February 12, 1992
LD-92-016

Subject: Response to NRC Requests for Additional Information

Reference: Letter, Structural and Geosciences Branch RAIs, T. V. Wambach (NRC) to
E. H. Kennedy (C-E), dated September 26, 1991

RESPONSE TO NRC REQUESTS FOR ADDITIONAL INFORMATION
STRUCTURAL AND GEOSCIENCES BRANCH

RAI 210.34

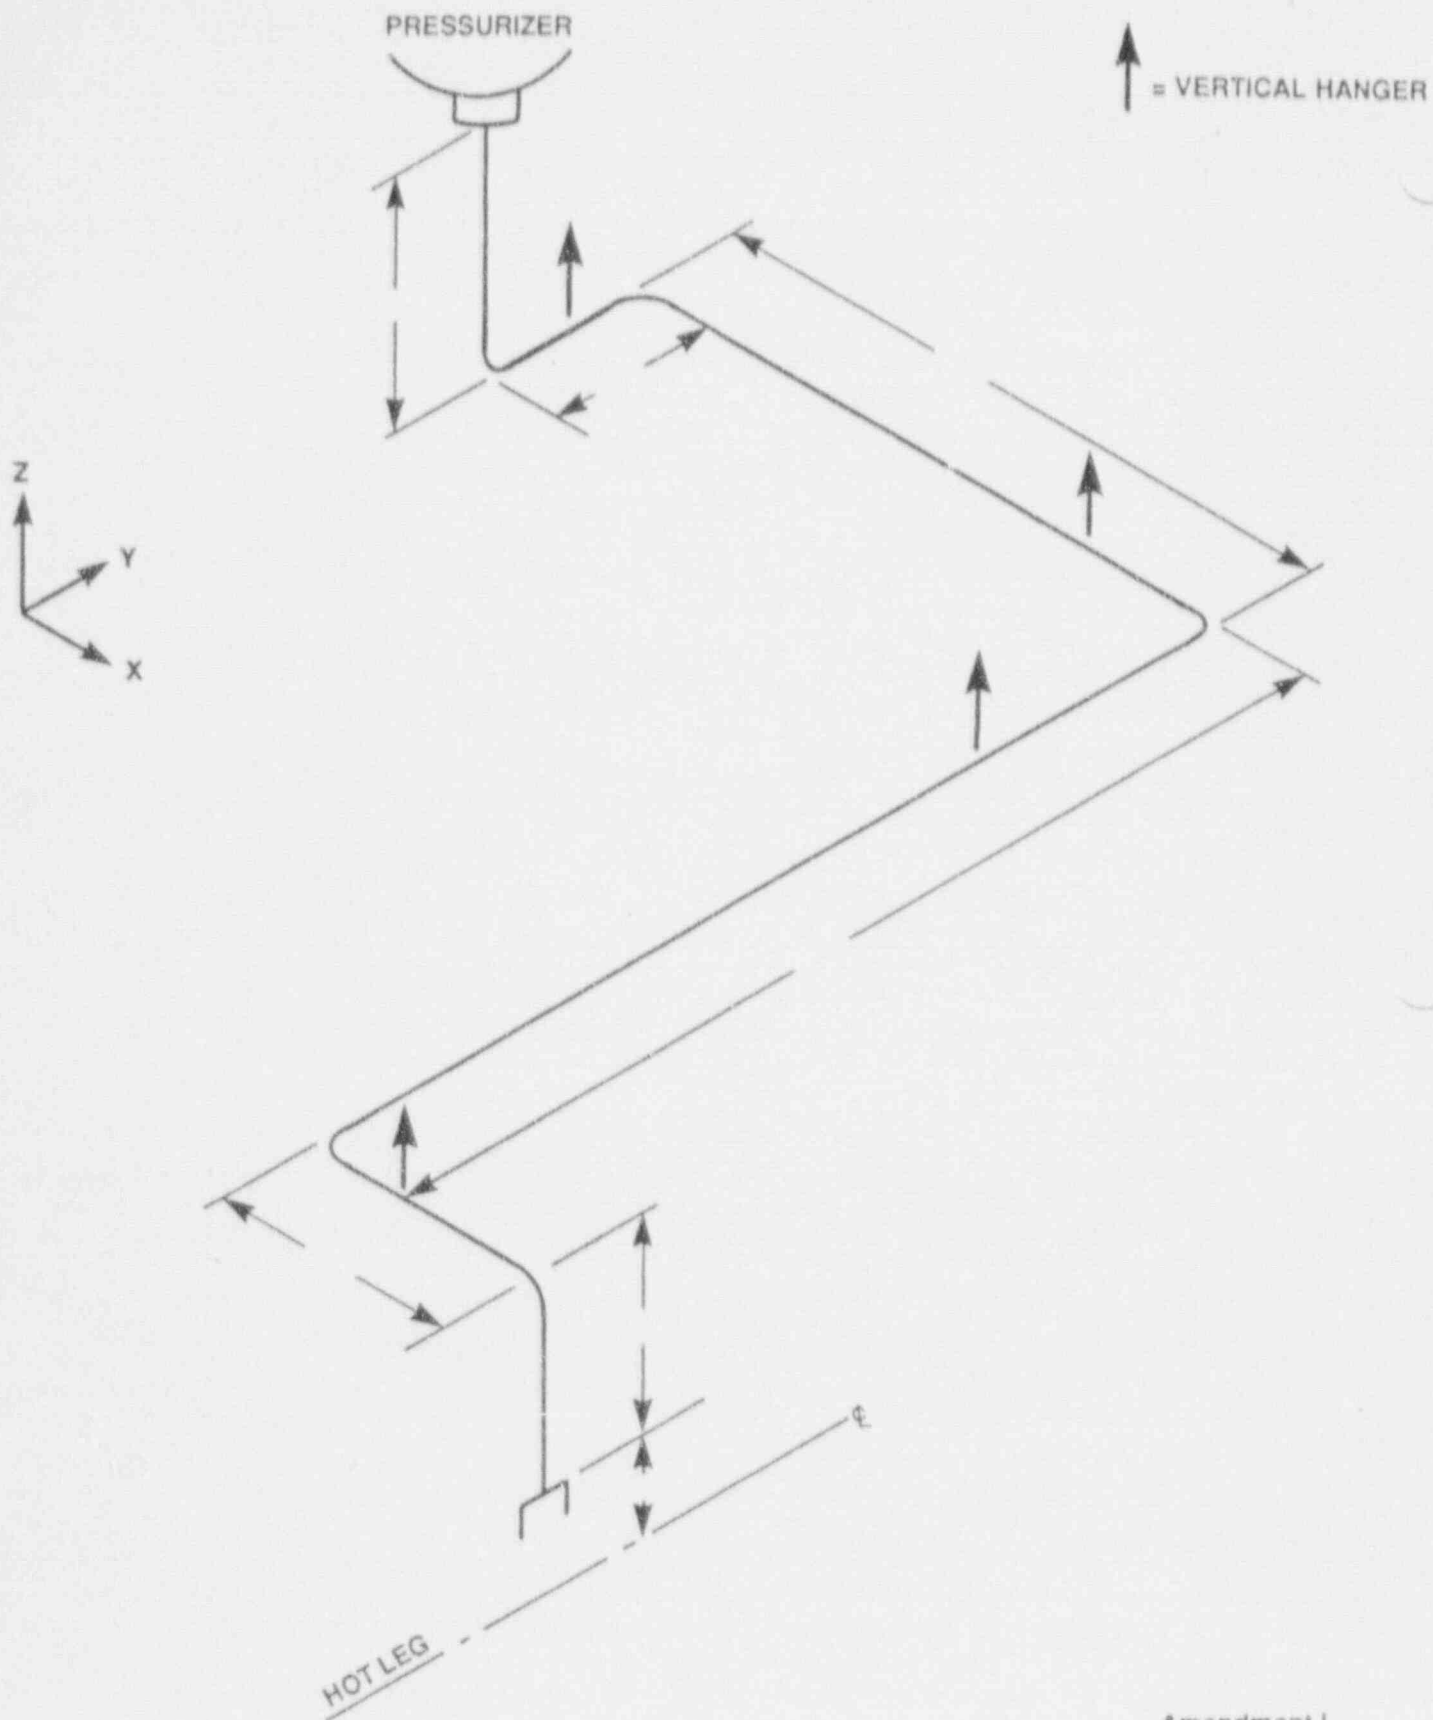
CESSAR-DC Section 3.7.2.1.2.2 states that a multimass model was used for the surge line dynamic analysis. The model is shown in Figure 3.7-34. However, no details of the number of mass points and degrees of freedom are provided.

The representative model of the surge line shown in Figure 3.7-34 has sixteen mass points, each with three degrees of freedom (x, y and z). The number of mass points required for the System 80+ surge line will be determined during the detailed design. The number of mass points and degrees of freedom will meet the requirements of the acceptance criteria of SRP 3.7.2, Rev. 2, Subsection II.1.a.(iii).

CESSAR-DC Section 3.7.2.1.2.2 and Figure 3.7-34 will be revised in a future submittal to note that Figure 3.7-34 is a representative surge line seismic analysis model.

A representative

A lumped parameter, multimass mathematical model is employed in the analysis of the surge line. ~~The~~ model is shown schematically in Figure 3.7-34. The surge line is modeled as a

Figure 220.12-1 - Axisymmetric model of the SCV used in fine-tuning of the SSI model.

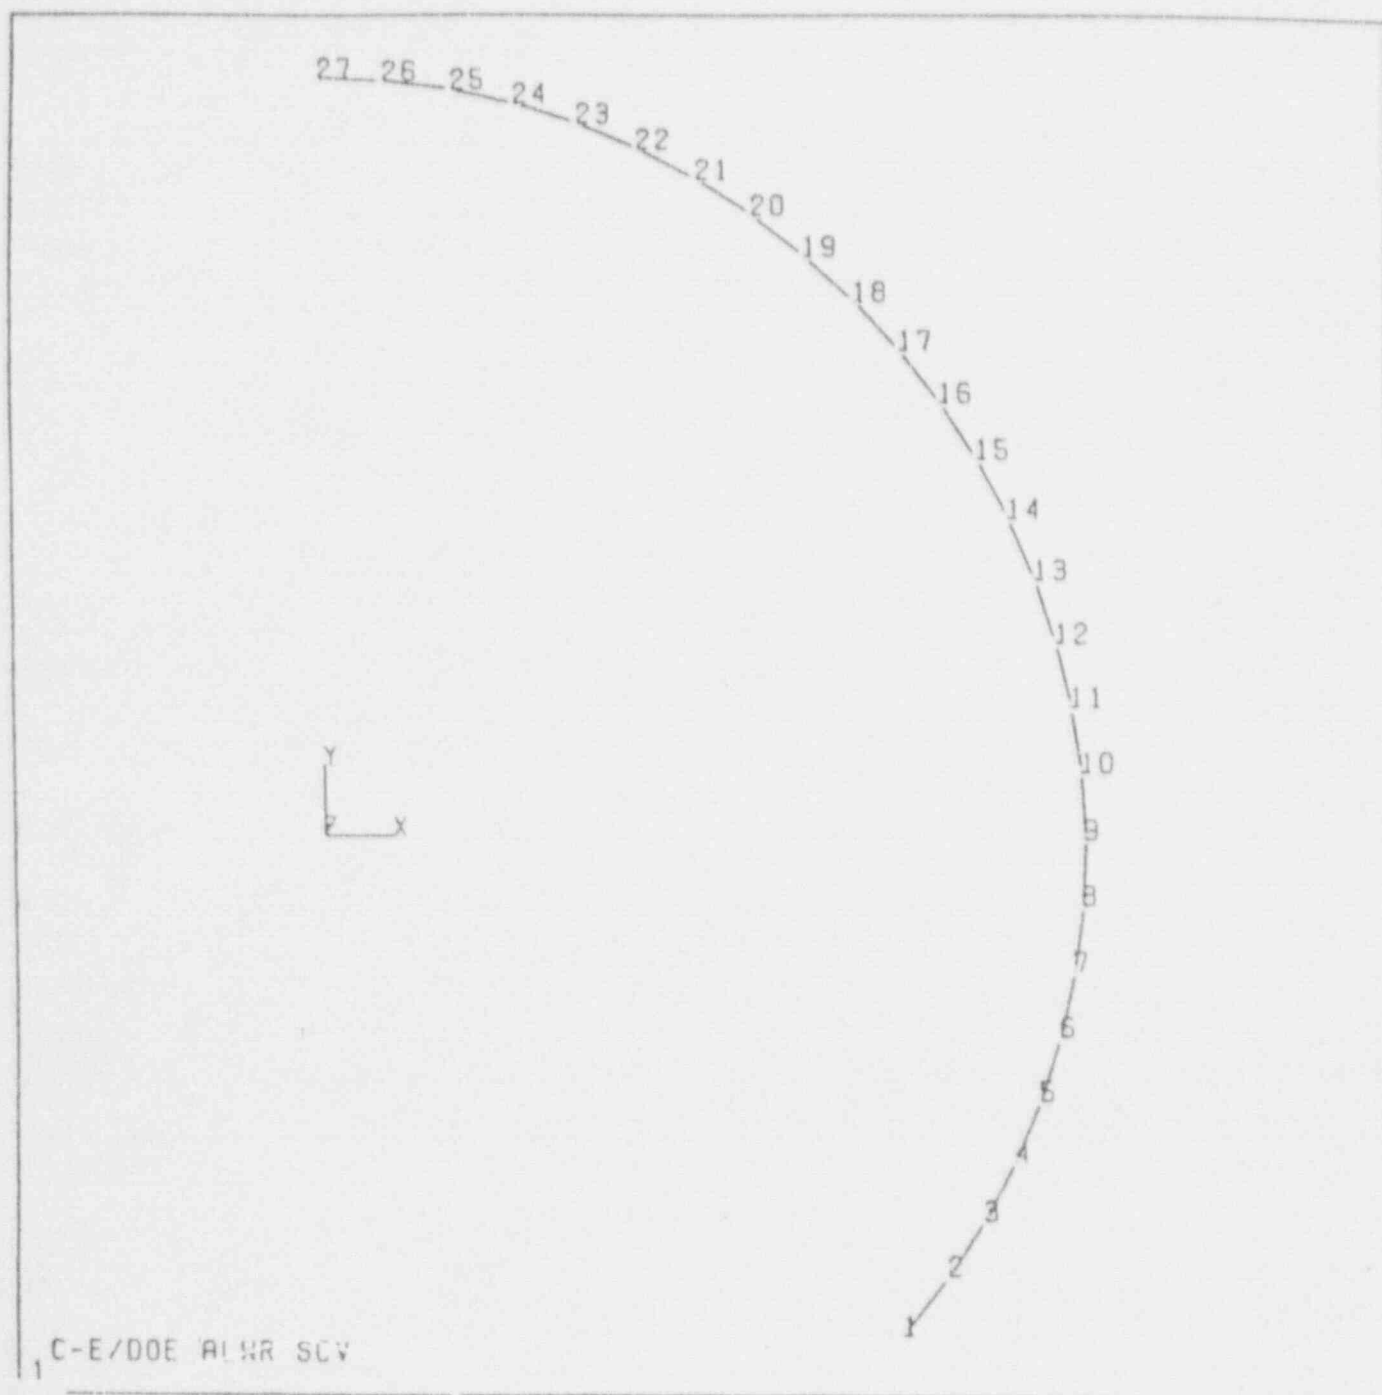
Section 3.7.2.1.1 - The mesh of the finite element model shown in Figure 3.7-30 seems coarse. Is there any parametric study performed to determine if stiffness characteristics of the containment vessel are properly represented by these coarse mesh finite elements?

The finite element model of the Steel Containment Vessel (SCV) shown in Figure 3.7-90 was used only in the soil-structure interaction (SSI) analysis. Typically, stick models are used in SSI analyses of containment structures. However, in order to capture more accurately "breathing" modes and other higher order modes of the containment, a finite element model with shell elements was developed for the SCV.

A comparison of the SCV SSI model with a more detailed axisymmetric model was made in order to fine tune the natural frequencies and mass participation factors of the SCV SSI model. The axisymmetric model shown in Figure 220.12.1 was developed with the computer program ANSYS and was used as a benchmark for this fine tuning. The SCV SSI model properties were adjusted to get a match of dynamic properties with the more detailed ANSYS model.

Figure 220.16-1 - Detailed 3D Finite Element Model of Internal Structure

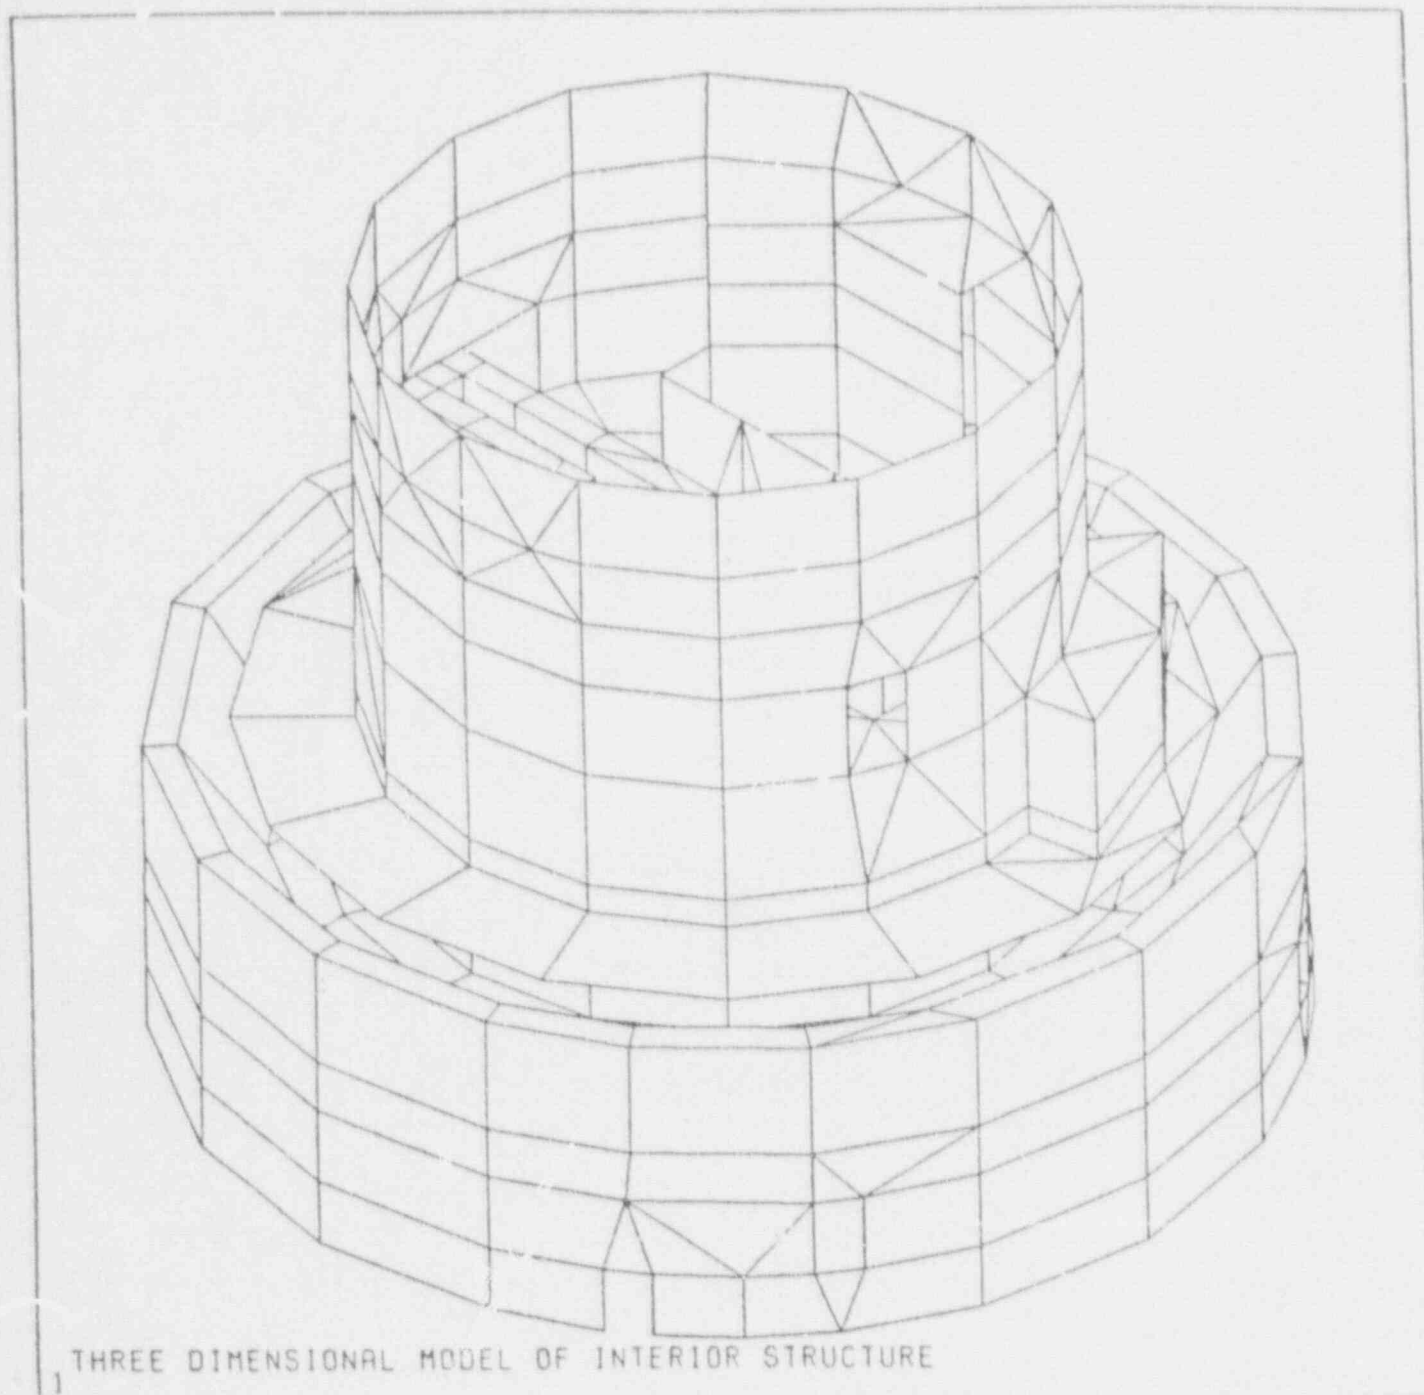
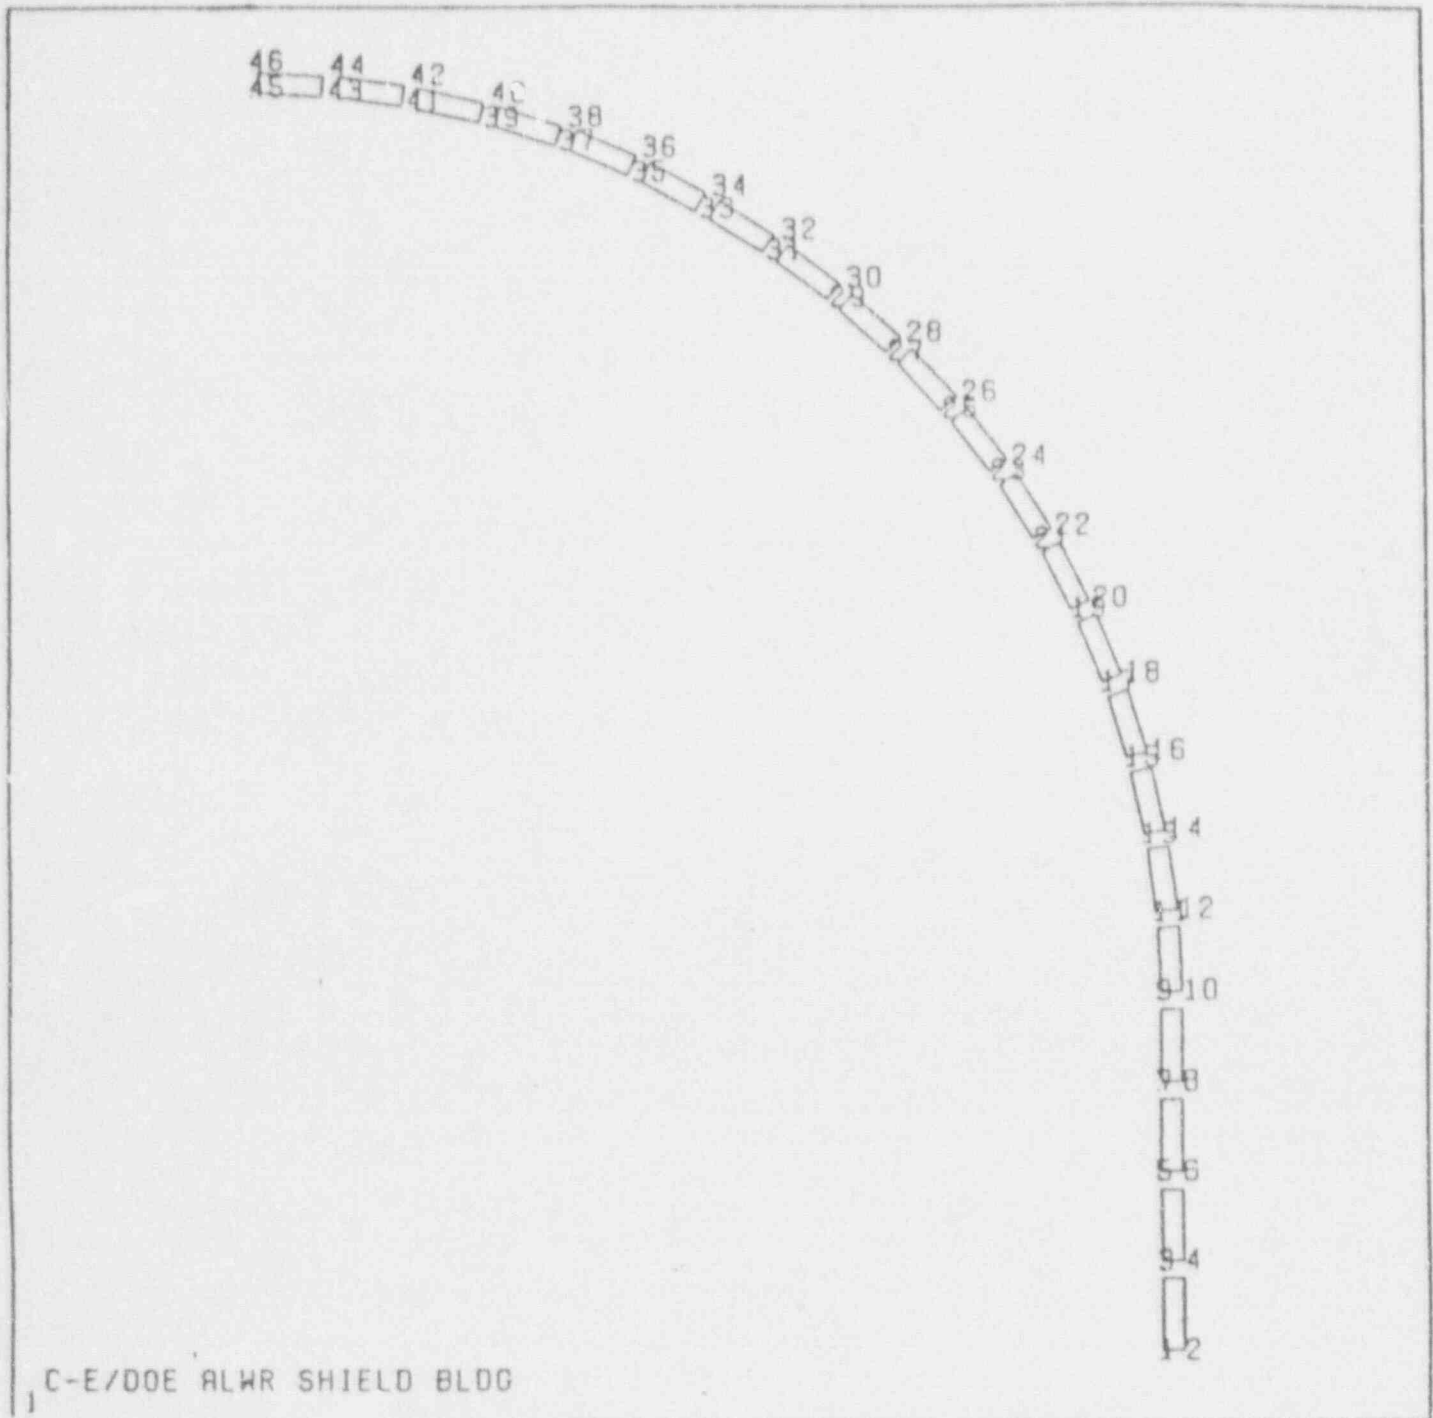
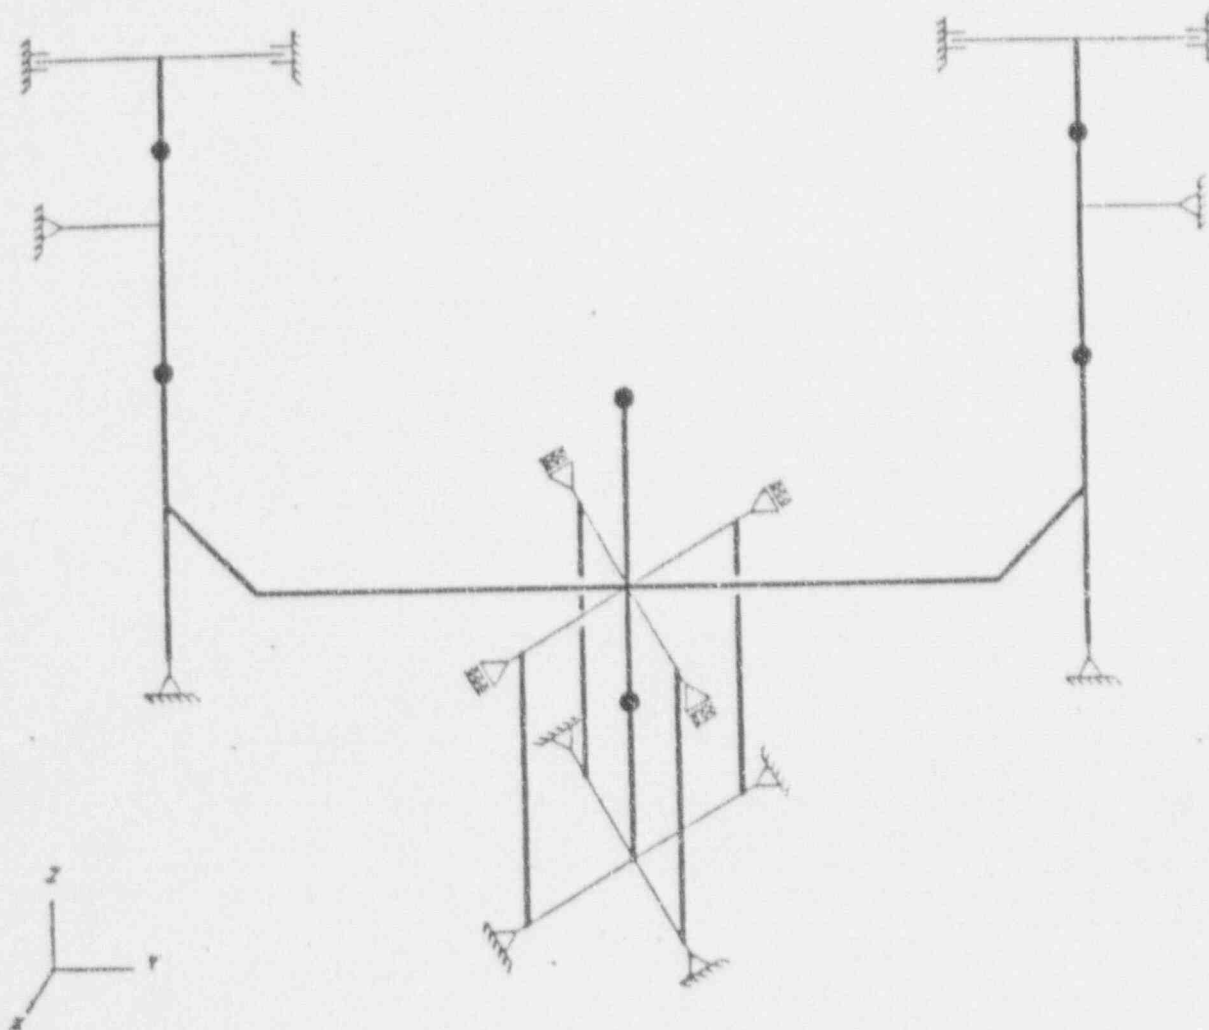
Section 3.7.2.1.1 - Does the combined model shown in Figure 3.7-31 include any simplified building or NSSS models? What are these simplified models? What is the purpose of this combined model? Provide some analysis results of this combined model.

The schematic of the model shown in Figure 3.7-31 represents the structural model of the Nuclear Island of the System 80+ Standard Design, which is used in the SSI analyses. The Nuclear Island model is composed of the models of the Internal Structure (IS), the Steel Containment Vessel (SCV), the Shield Building (SB) and the NSSS, together with the models of the Fuel Building, Control Building, Auxiliary Building and Diesel Generator Buildings (Nuclear Annex structures).

As described in Section 3.7.2.3.4.1 of CESSAR-DC, the IS stick model was developed and fine tuned based on a detailed 3D finite element model. The detailed 3D finite element model is shown in Figure 220.16-1, and it was developed according to the procedure described in Section 3.7.2.3.4.1.1 of CESSAR-DC. In a similar manner, the SB stick model was developed and fine tuned based on a detailed axisymmetric model of the SB, shown in Figure 220.16-2.

The IS and SB stick models are essentially co-axial (except for floor eccentricities in the IS). Since the IS and the SB are monolithically constructed, the stick models of these structures are connected with a rigid link at elevation +115 ft. The SCV is also connected to the IS with rigid links at elevation +91 ft. The NSSS model used in the SSI analysis is shown in Figure 220.16-3 and is connected to the IS stick model at several elevations using appropriate links whose properties depend on the flexibility of the connection. The NSSS SSI model is a simplified model of the detailed NSSS model shown in Figure 3.7-32 of CESSAR-DC. This simplified model is only used in the SSI analyses.
